International Energy Conservation Code Consensus Committee-Residential

Draft Meeting Agenda (6/10 posting)

June 16, 2022

International Energy Conservation Code Code Change Proposal Tracking Sheet

Figure 2. Floor plan of HRV, exhaust fans, and duct layout for proposed case.

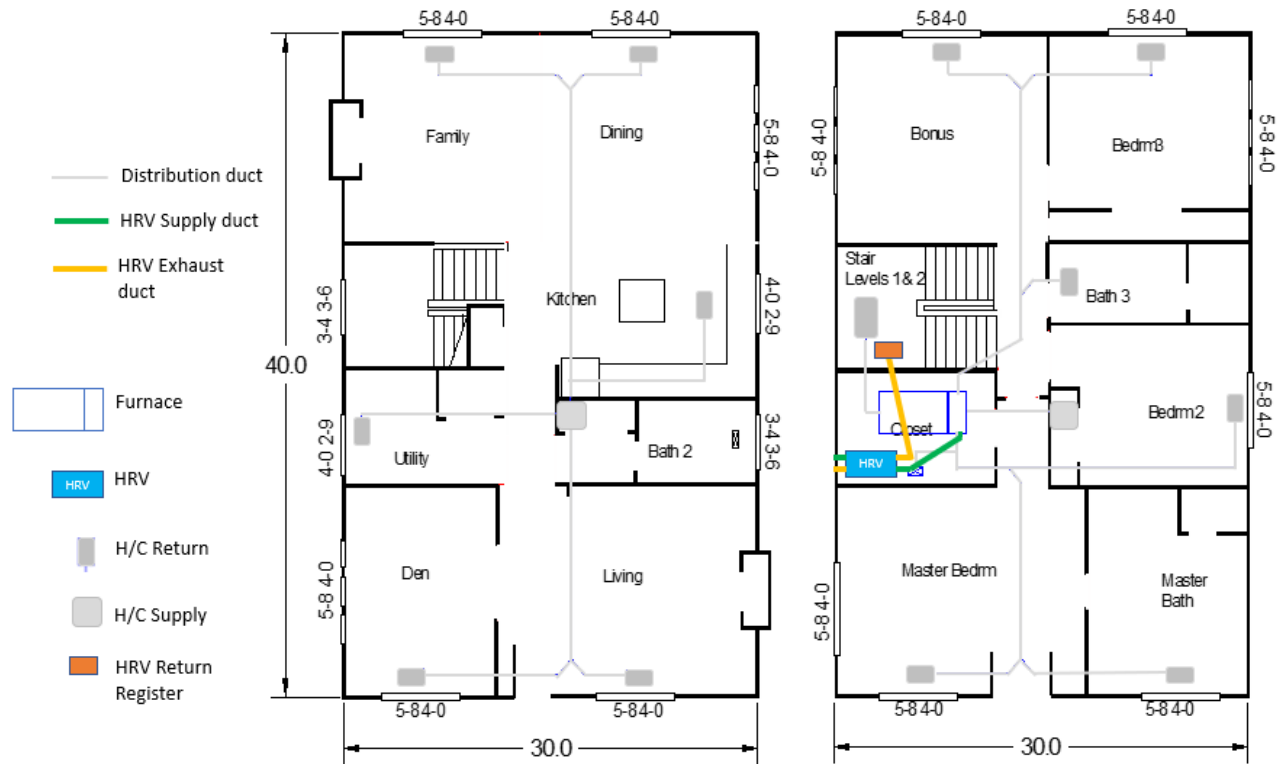
To determine duct lengths, the proposal team developed a floor plan for the prototype home, and identified differences for the base case (exhaust-only ventilation) and proposed case (HRV).

The proposed case assumes one HRV serving the home. The proposed requirement affects ventilation equipment only, so does not affect ductwork. But for cost assumptions, the proposal team assumed that HRV return grille is located in the middle of the home, close to the heating system return grille. The team assumed the HRV's supply duct (providing pre-heated or pre-cooled fresh air) connects to the heating and cooling system ductwork, which would distribute the ventilation air. For heating and cooling
